Access Compliance Report

Public Rights-of-Way

(Curb Ramps)

Intersection ID: 29769	Main Street: BRAMBLE_CREEK_DR	Cross Street: FAWN_HILL_RD	Location:	N
ADA ID: 93ED5804120B	Ramp Type: BlendTrans1	Initial Pass/Fail: Fail	Overall Compliance: No	Severity Score: 21.25
Codes/Mitigation Info/Possible Solution		Field Measurements/Component Compliance

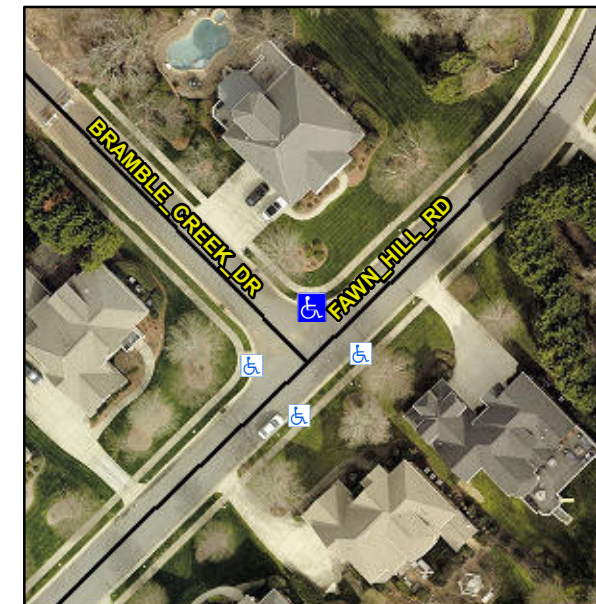
Not Found, R304.5.1, R304.5.3

Compliance	Description	Data	Compliance	Description	Data
N/A	Ramp Length (in)	47.0	Yes	BlendTrans Slope (%)	1.7
No	Ramp Width (in)	38.0	No	BlendTrans XSlope (%)	5.5
N/A	Flare Type LT	N/A	N/A	Flare Type RT	N/A
N/A	Flare Slope LT (%)	N/A	N/A	Flare Slope RT (%)	N/A
N/A	Flare Traversable LT?	N/A	N/A	Flare Traversable RT?	N/A
N/A	Landing Length (in)	N/A	N/A	DWS Provided?	N/A
N/A	Landing Width (in)	N/A	N/A	DWS Contrast?	N/A
N/A	Landing Slope (%)	N/A	N/A	DWS Length (in)	N/A
N/A	Landing X Slope (%)	N/A	N/A	DWS Full Width?	N/A
N/A	Landing Curb? (Y/N)	N/A	N/A	DWS Offset (in)	N/A
N/A	Shared Landing?	N/A			
N/A	Gutter Ponding?	N/A	N/A	Gutter Slope (%)	N/A
N/A	Gutter Lip Ht (in)	N/A	N/A	Gutter X Slope (%)	N/A
N/A	Painted X Walk1?	No	N/A	Painted X Walk2?	No
	X Walk 1 Direction	To SW		X Walk 2 Direction	To SE
	X Walk 1 Width (in)	N/A		X Walk 2 Width (in)	N/A
	X Walk 1 Slope (%)	2.1		X Walk 2 Slope (%)	1.4
	X Walk 1 X Slope (%)	4.4		X Walk 2 X Slope (%)	3.3

N/A	Ramp inside XWalk1?	N/A	N/A	Ramp inside XWalk2?	N/A
	Road Slope (%)	3.9		Clear Space?	N/A
	Road X Slope (%)	1.0	N/A	Clear Space to XWalk (in)	N/A
N/A	Any Obstructions?	N/A	N/A	Storm Grate/Utility Hazard?	N/A
	Obstruction Type			Storm Grate/Utility Type	
		N/A			N/A
			Yes	Surface Condition? (G/P)	Good
			No	Curb Slope (%)	8.8

Remove & Replace Curb Ramp With Two New Directional Ramps or Equivalent.
